ACCESSION NBR: 8504030105 DOC. DATE: 85/03/29 NOTARIZED: NO DOCKET #
 FACIL: 50-305 Kewaunee Nuclear Power Plant, Wisconsin Public Service 05000305
 AUTH. NAME AUTHOR AFFILIATION
 HINTZ, D.C. Wisconsin Public Service Corp.
 RECIP. NAME: RECIPIENT AFFILIATION
 VARGA, S.A. Operating Reactors Branch 1

SUBJECT: Forwards response to NRC 841130 request for addl info re
 reactor inventory tracking sys & subcooling margin monitor.
 Updated description of trackign sys also encl.

Docket 50-305
Operating License DPR-43
Kewaunee Nuclear Power Plant
TAC #M45143
Proposed Inadequate Core Cooling Instrumentation (ICC)

Request for Additional Information on Proposed
Inadequate Core Cooling Monitor

FIGURE 1

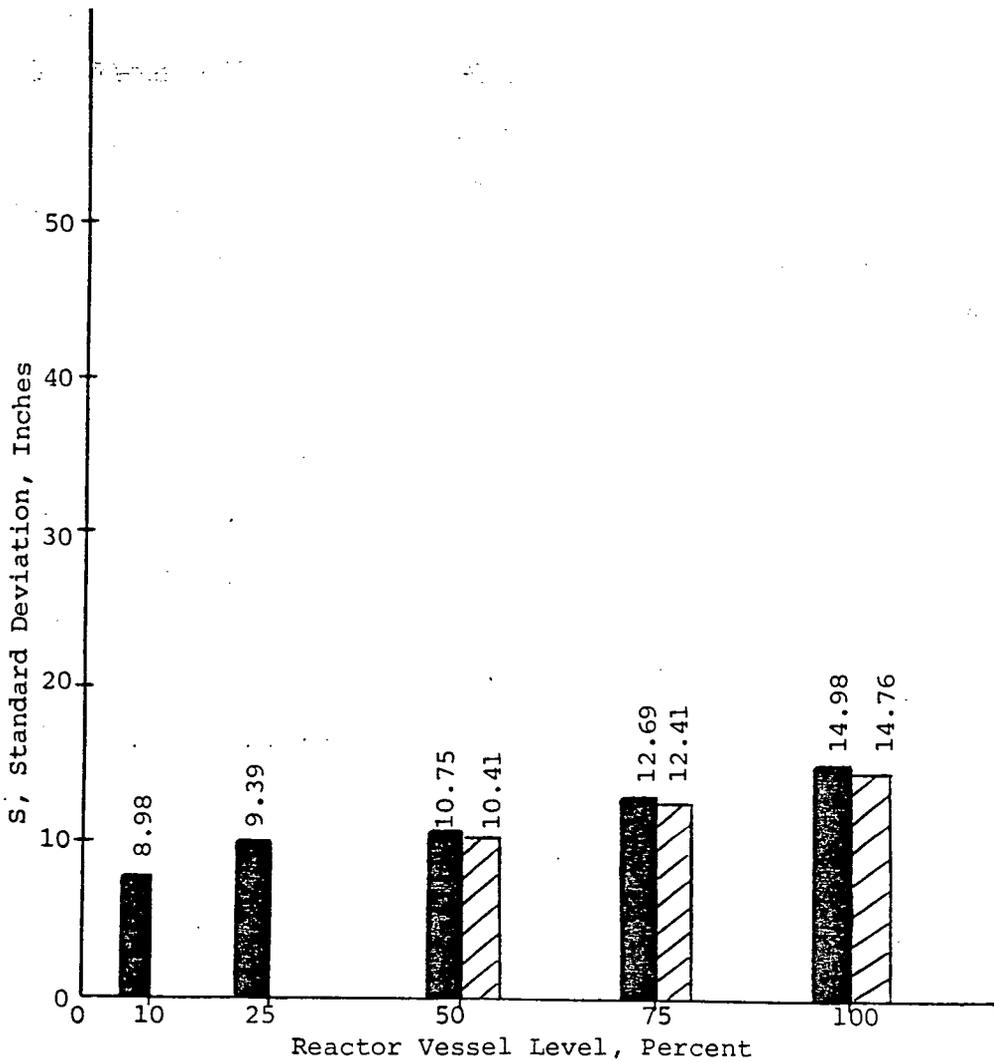
1. QUESTION: Provide an analysis of the expected errors in the reactor vessel level measurements. This analysis should include not only an overall estimate of the measurement uncertainty, but estimates of each contributing factor, i.e., temperature of the impulse lines, common mode pressure effects on the differential pressure transducer, and uncertainties associated with the transducer. Explain how the individual errors are combined to give an estimate of the overall error. Note: other applicants have encountered difficulty in achieving satisfactory accuracy with dp transmitters located inside containment in a LOCA environment.

RESPONSE: See attached uncertainty analysis.

During normal operating conditions, the total system uncertainty for the Reactor Vessel Level System is +15". During the most severe LOCA conditions, the total system uncertainty is +26" for vessel level approaching core un-coverry. See Figures 1-3 for additional detail.

Case: Normal Operating Conditions, T=120°F

FIGURE 2

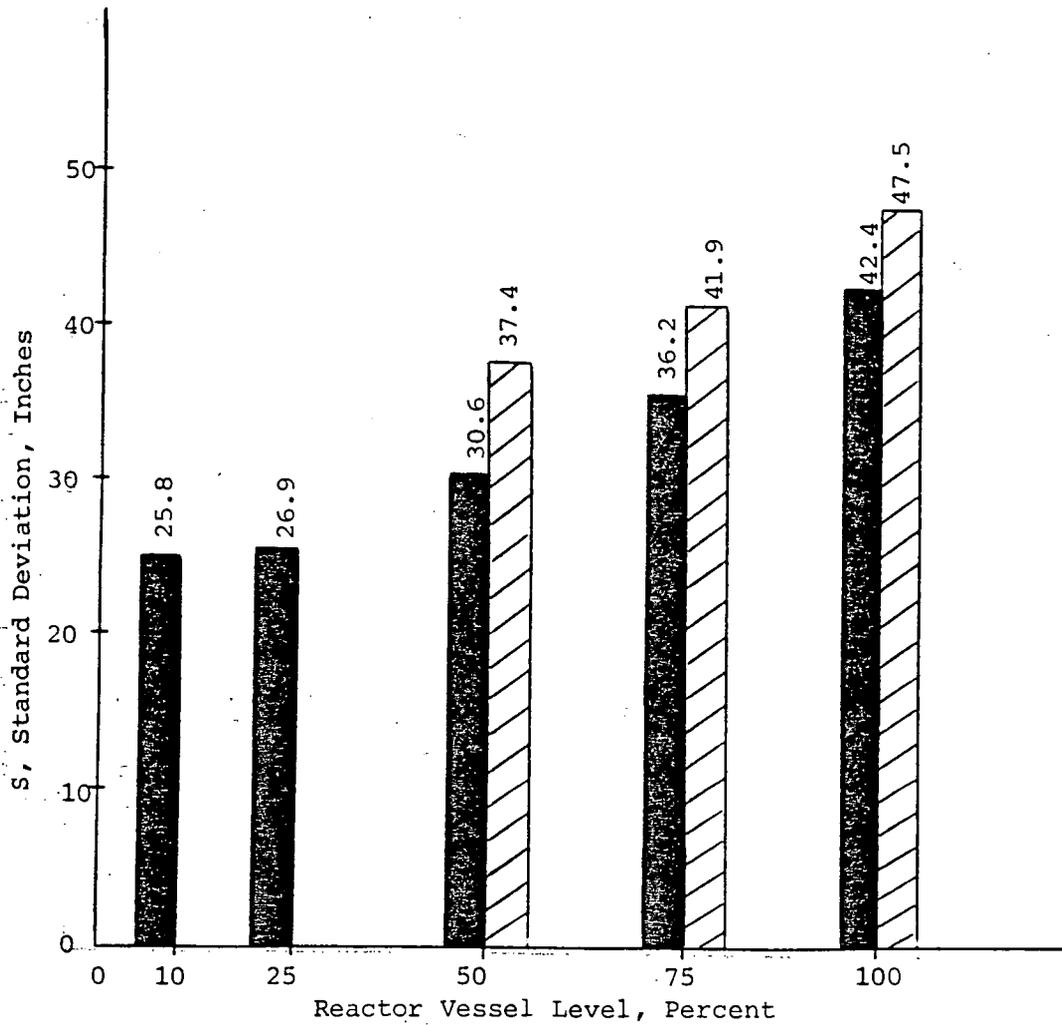
2. QUESTION: Discuss the ability of the transmitters to withstand a LOCA environment within the containment and be available for post-accident monitoring--consider the loss of the pressurizer transmitters in the TMI-2 accident in this discussion.

Case: Peak LOCA Conditions, T=293°F
